**TO:** District of Columbia Zoning Commission *JLS*  
**FROM:** Jennifer Steingasser, Deputy Director, Development Review & Historic Preservation  
**DATE:** November 13, 2015  
**SUBJECT:** Preliminary Report – ZC 15-15 – Consolidated PUD at 1500 Harry Thomas Way / 1611-1625 Eckington Place, N.E., with Related Map Amendment from M to CR; Square 3576, Lots 2001-2008

**Figure 1. Site and Context**

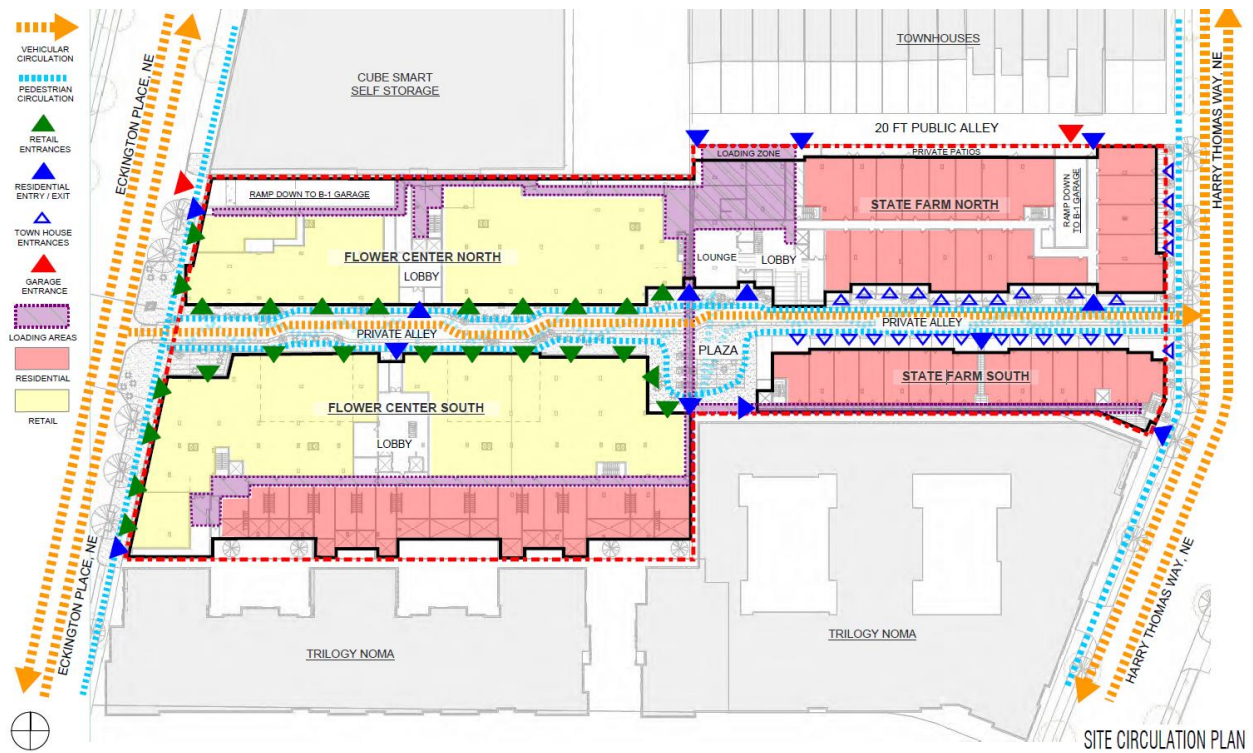
The applicant is working with ANC 5E to identify the public benefits of special value to the neighborhood that would be commensurate with the related map amendment and increases in height and density. The applicant is also working with the District Department of Transportation (DDOT) on the scope of work needed for the transportation and parking consultant’s report, and

Figure 2. Generalized Site Plan

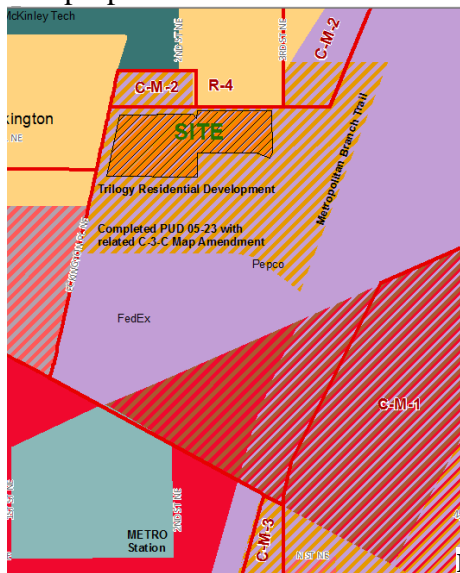
§ 638.2(a): The closed courts are primarily adjacent to the east-west pedestrian way. Their dimensions, while somewhat less than required, would be augmented by the width of the east-west pedestrian way, which would be 20 feet wide east of the central plaza and 30 feet wide west of the plaza;

Sheets A1.09 and A1/10 illustrate the circulation in and around the site. Parking and loading would be entered primarily from Eckington Place and a public alley at the northeast corner of the site. The applicant is considering an additional, southern, loading entry through an arrangement with the Trilogy/Gale PUD 05-23.
